# **Falcon Highlands South**

## **Preliminary Drainage Report**

**September 20, 2023**

**PUDSP-22-005**

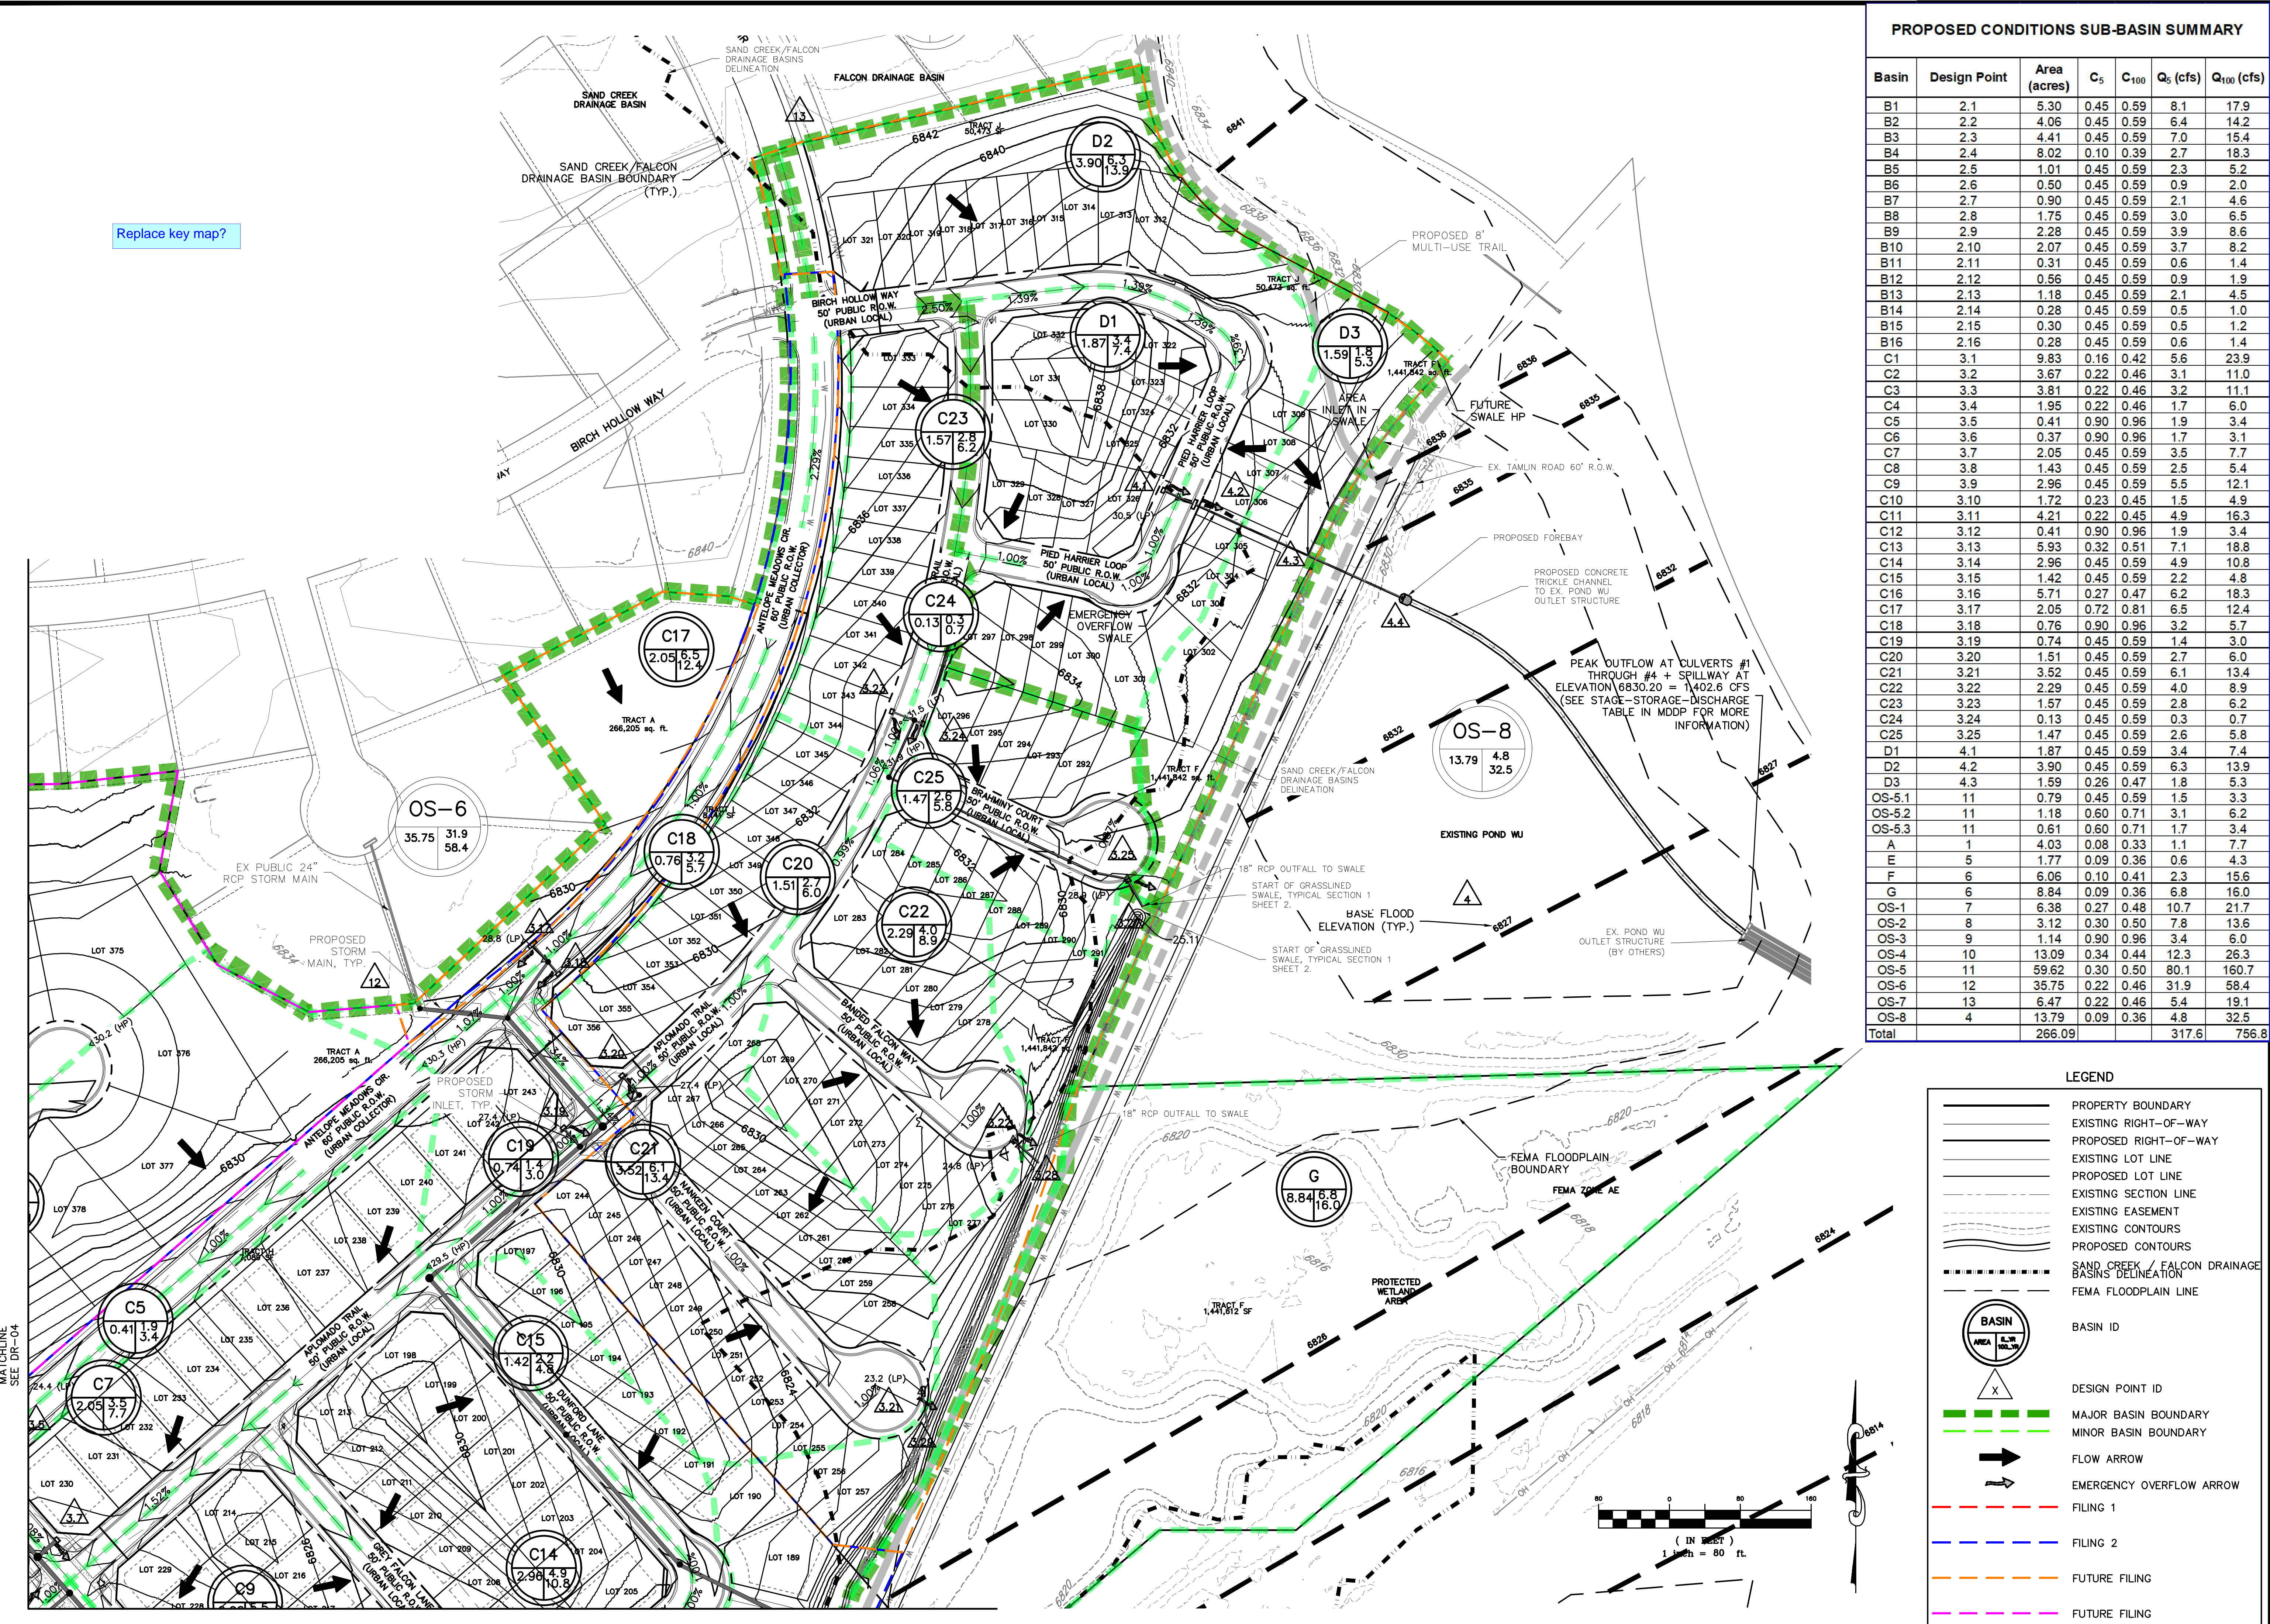
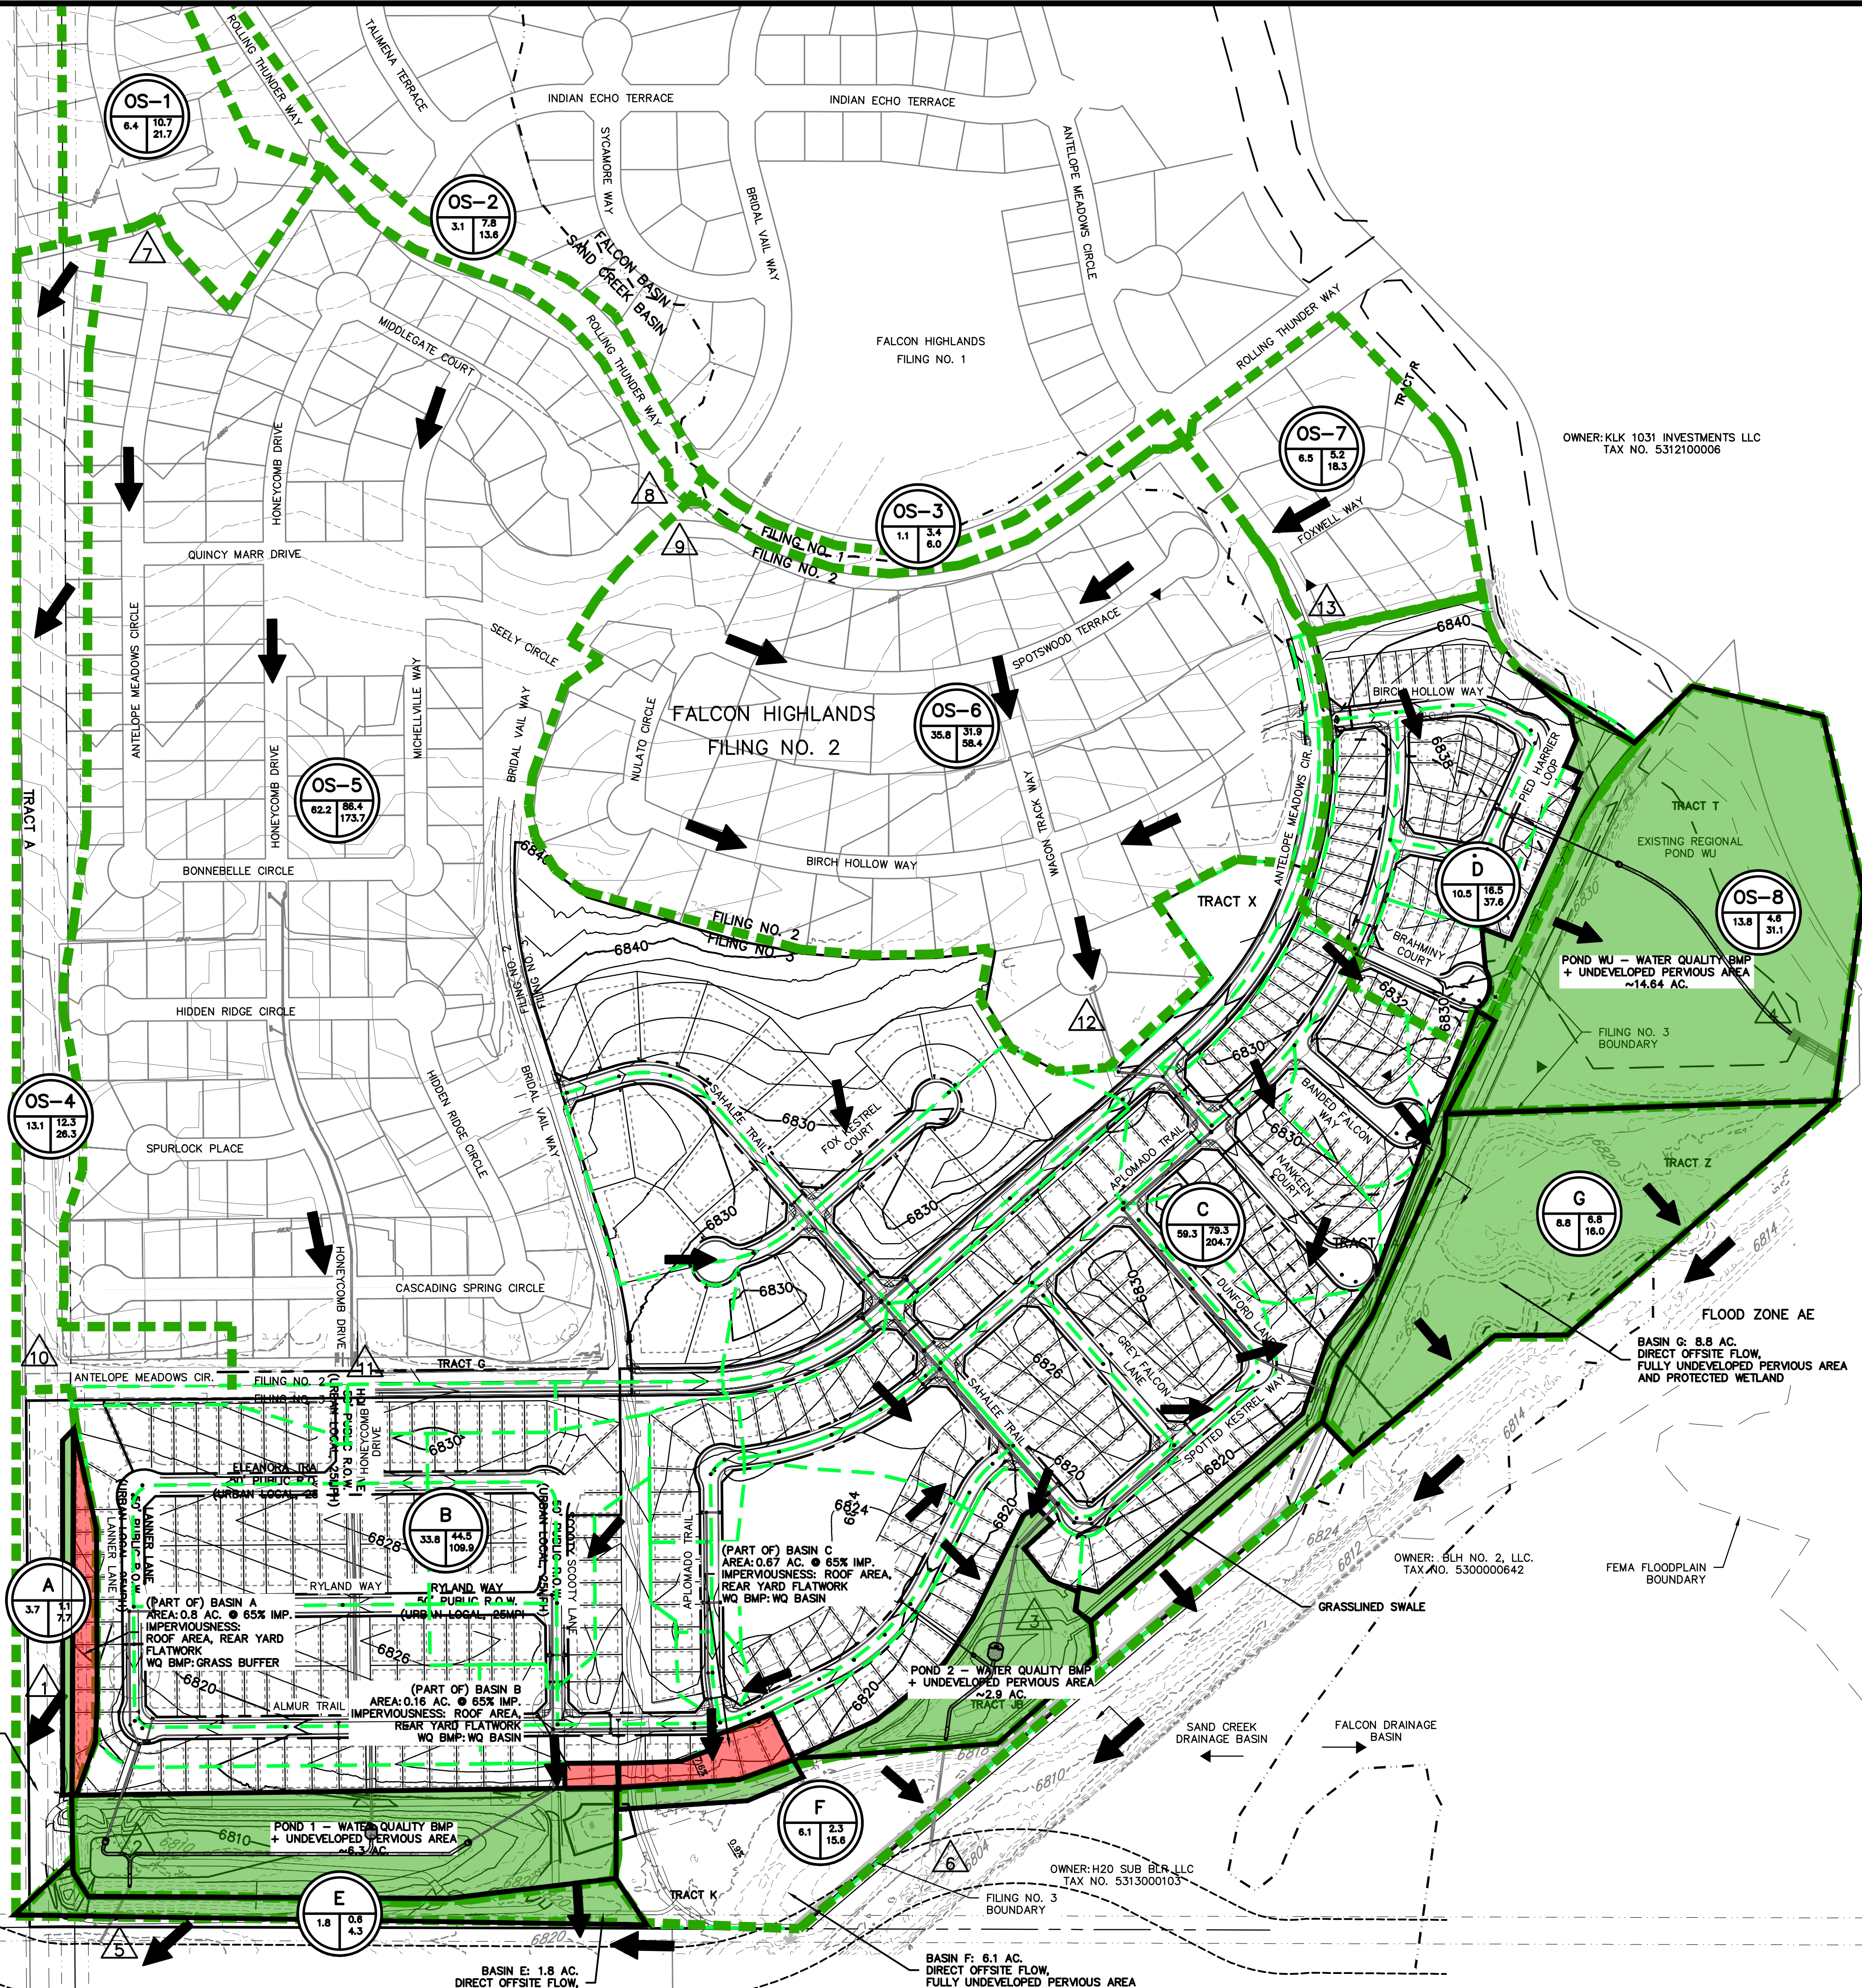
Replace key map?
